ADDENDUM NUMBER: **Five (5)**

TITLE: **Construction for Northwest Regional Water Treatment Plant (WTP)**

JEA IFB NUMBER: **073-16**

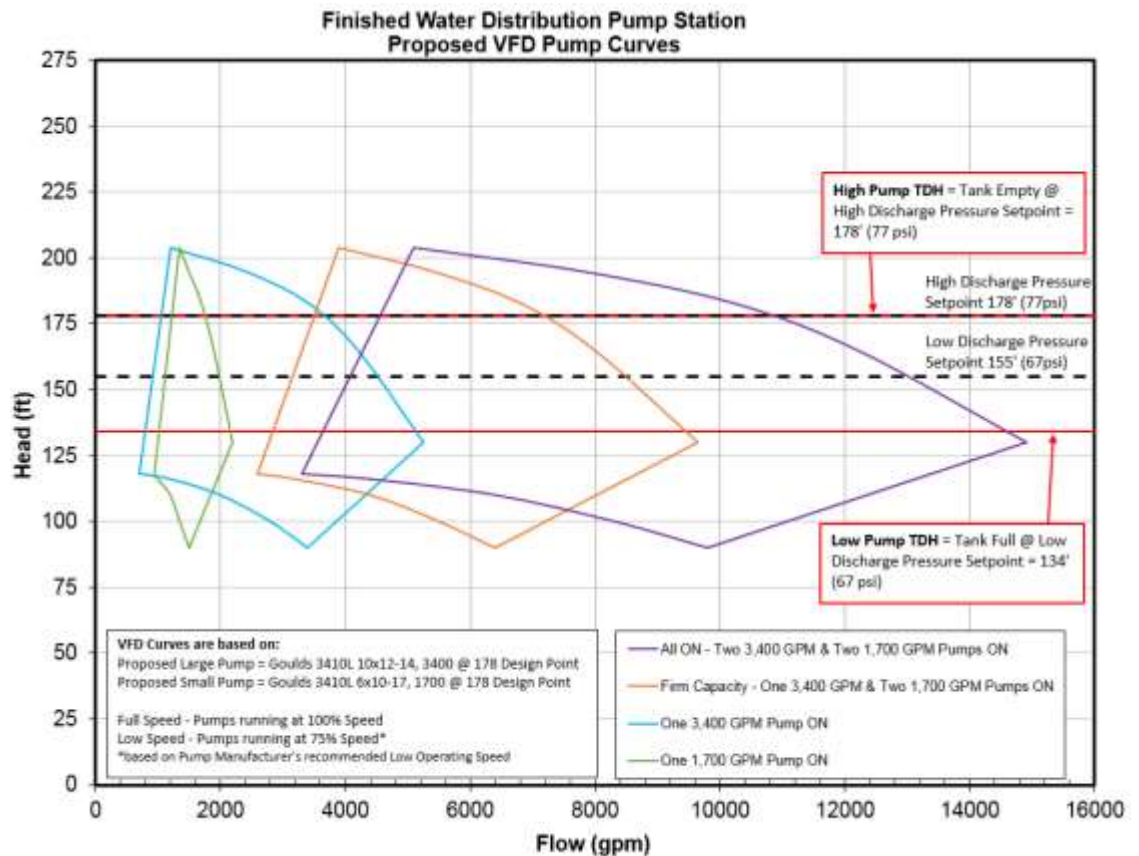
- **RESPONSE:** The pumps & bases are to be factory primed and finish coated per System No. 4 in Section 09 90 00.
- Supplement
  - The Peerless pump proposed for the large high service pumps has a shutoff head of approximate 228’. Is this deviation acceptable?

- Regarding the 250hp driver for the large high service pumps, please confirm that this is a maximum value and smaller hp motors & associated VFDs can be provided if it meets the requirements of the spec as non-overloading. Smaller motors & associated VFDs would be more cost effective.

- The Peerless pump proposed for the small high service pumps has an NPSHRE of 12.5' at the rated capacity. Is this deviation acceptable? This should not be an issue with the specified 30.7' NPSHA.

- **RESPONSE:** The specified pump data sheets are based off a design pump from one of the JEA approved horizontal split case pump manufacturers (Goulds). An alternate JEA approved manufacturer pump selection with higher shutoff heads and/or smaller motor sizes may be acceptable provided they meet the Specifications. At a minimum, the firm capacity of the two large and two small selected pumps at 100% speed shall be 6,800 gpm. The selected pumps should cover the anticipated full operating TDH window using VFDs without operating point gaps. The below graph shows the operating coverage of the design pumps (Goulds) as an example:

Also, the selected pumps can have different NPSHr from the specified pump data sheet provided this does not exceed the specified NPSHa
